MEMORANDUM

SUBJECT: LO-Tigard WTP, 4260 Kenthorpe Way, West Linn - Land Use Review Comments

DATE: December 28, 2011

LAKE OSWEGO AND TIGARD WATER TREATMENT PLANT
DESIGN REVIEW AND CONDITIONAL USE
FIRE AND EMERGENCY ACCESS PLAN

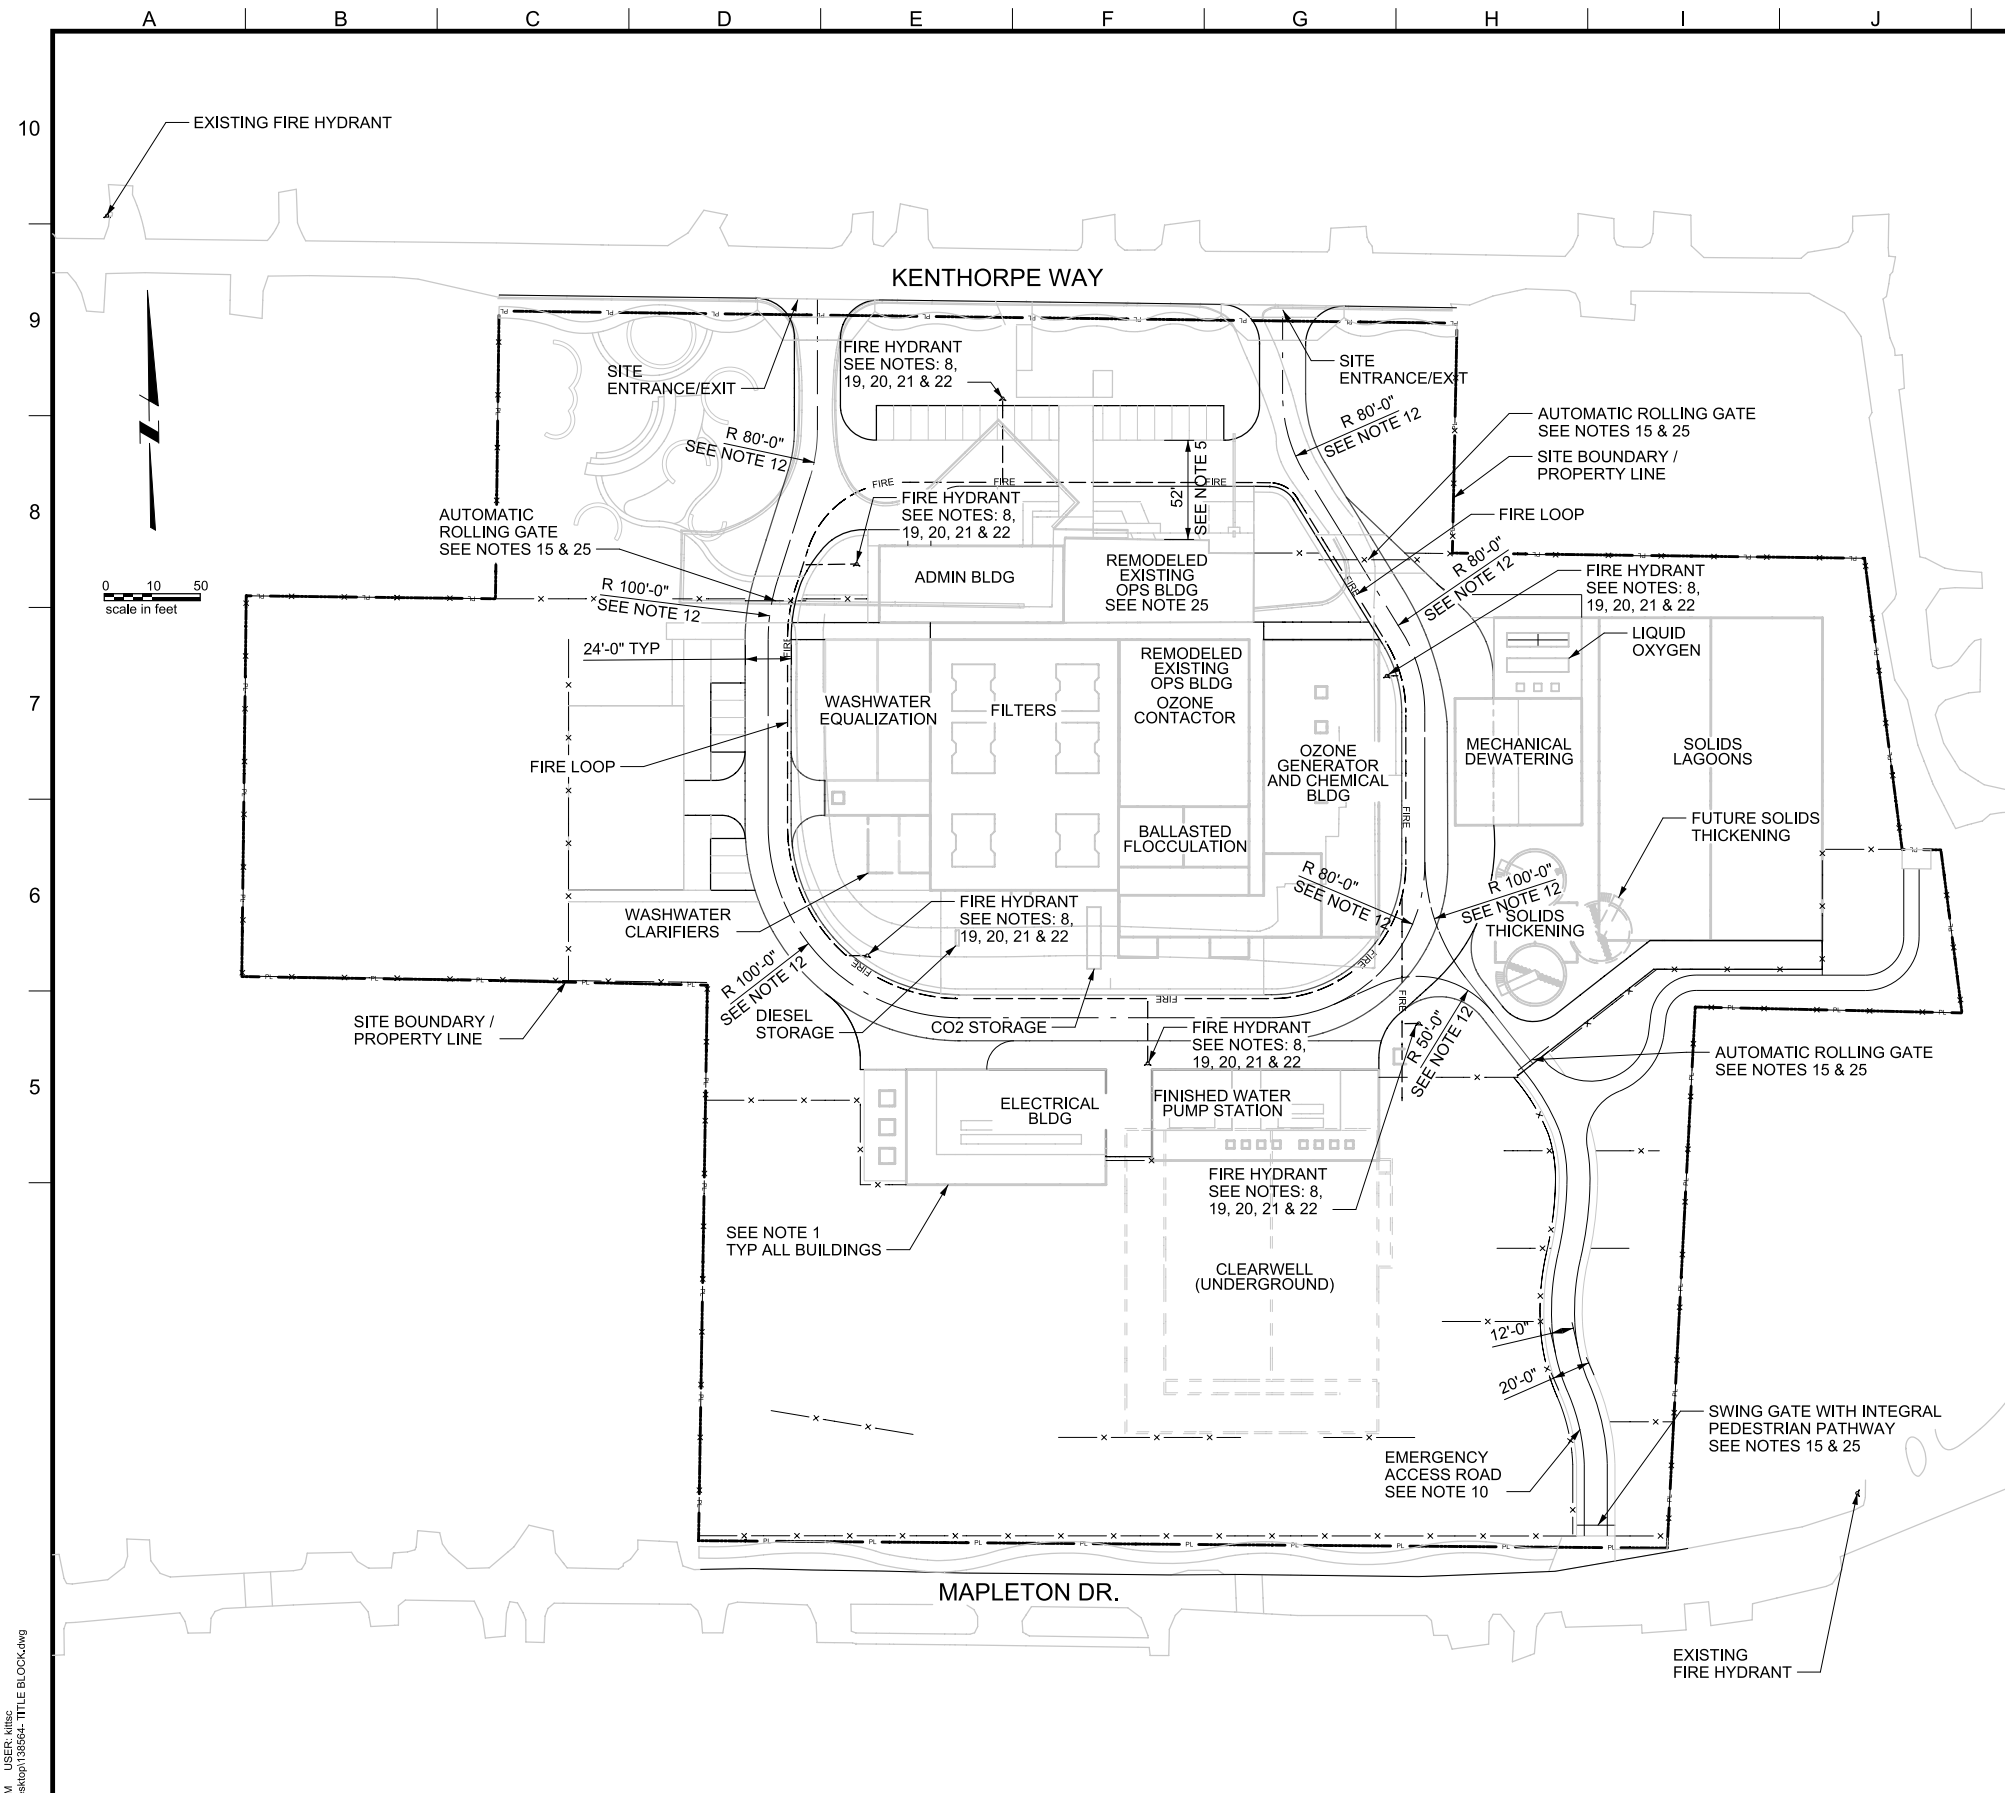
- 17) **FIRE HYDRANTS – COMMERCIAL BUILDINGS:** Where a portion of the building is more than 400 feet from a hydrant on a fire apparatus access road, as measured in an approved route around the exterior of the building, on-site fire hydrants and mains shall be provided. This distance may be increased to 600 feet for buildings equipped throughout with an approved automatic sprinkler system. (OFC 508.5.1)

Please show hydrant locations for approval.

- 18) **FIRE HYDRANT NUMBER AND DISTRIBUTION:** The minimum number and distribution of fire hydrants available to a building shall not be less than that listed in Appendix C, Table C 105.1.

- 19) **FIRE HYDRANT DISTANCE FROM AN ACCESS ROAD:** Fire hydrants shall be located not more than 15 feet from an approved fire apparatus access roadway. (OFC C102.1)

Response: Fire hydrants will be provided on-site and around the perimeter of the internal access road and in front of the Administration and Operations Buildings. See the attached Fire and Emergency Access Plan, showing the location of each fire hydrant on-site in compliance with this standard.

Response: See the attached Fire and Emergency Access Plan, showing the location of each fire hydrant on-site in compliance with this standard.

Response: No fire hydrant will be more than 15 feet from an approved access road. See the attached Fire and Emergency Access Plan, showing the location of each fire hydrant on-site in compliance with this standard.
